In the Matter of Xcel Energy's 2020 Hosting
Capacity Report

Docket No. E002/M-20-812

**COMMENTS OF THE INTERSTATE RENEWABLE ENERGY COUNCIL, INC. ON
XCEL ENERGY'S 2020 HOSTING CAPACITY ANALYSIS**

DATED: April 7, 2021

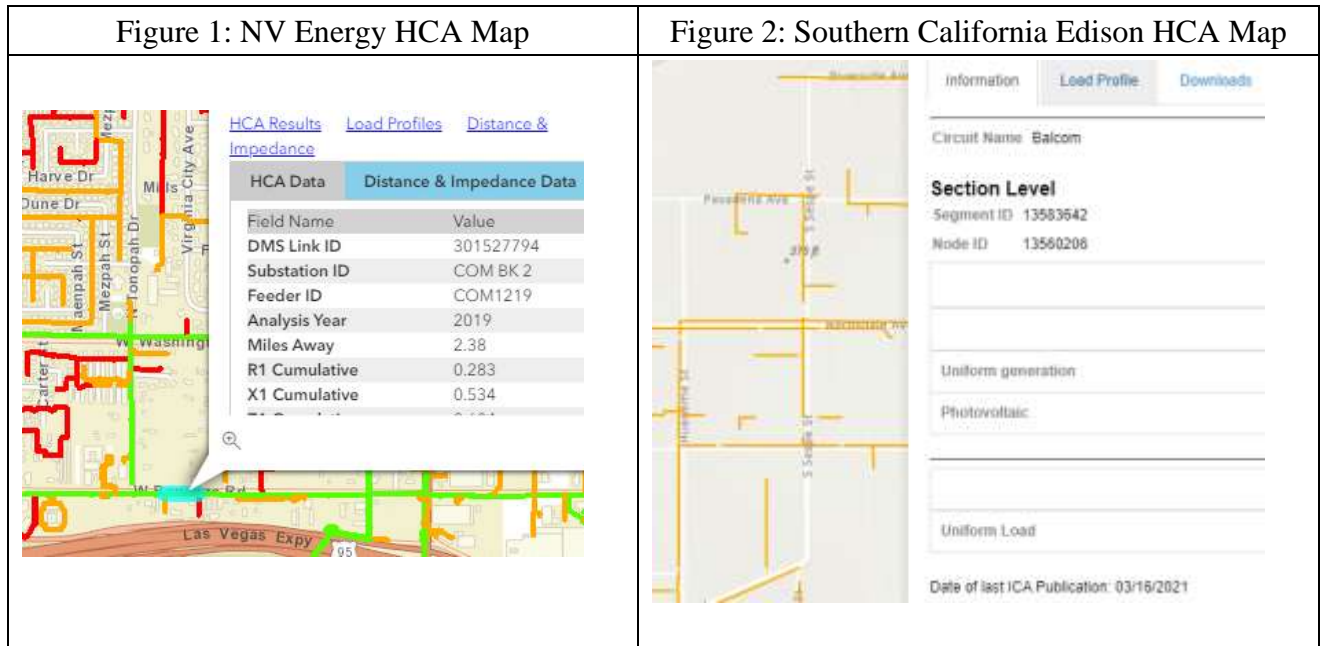
Xcel is "able to display all HCA values and primary criteria violations" on the HCA map, but does "not do so due to concerns of readability/usability."³⁰ Xcel claims it cannot present unique line segment numbers on the map due to "technical limitations" associated with aggregating nodal results into line segments.³¹ Yet multiple other utilities present this data—plus much more—on their HCA maps without problems. For example, Figure 1 below shows that NV Energy allows access to criteria violation values on its HCA map with a link to downloadable HCA results for that location in the pop-up box. Figure 2 shows that Southern California

Edison’s map similarly includes link to downloadable HCA criteria violation values for that location, as well as the line segment ID and node ID.

Xcel offers that if the Commission determines there is “value in including all violations and HCA values within the heat map pop-up” it will do so.³³ Yet the Commission already made this determination when OP 15 required that “Xcel must publish” the information on its HCA map.³⁴ There is no excuse for further delay. The Commission should order Xcel to fully comply with the requirements of OP 11 and OP 15 to publish this information on its map within 30 days.
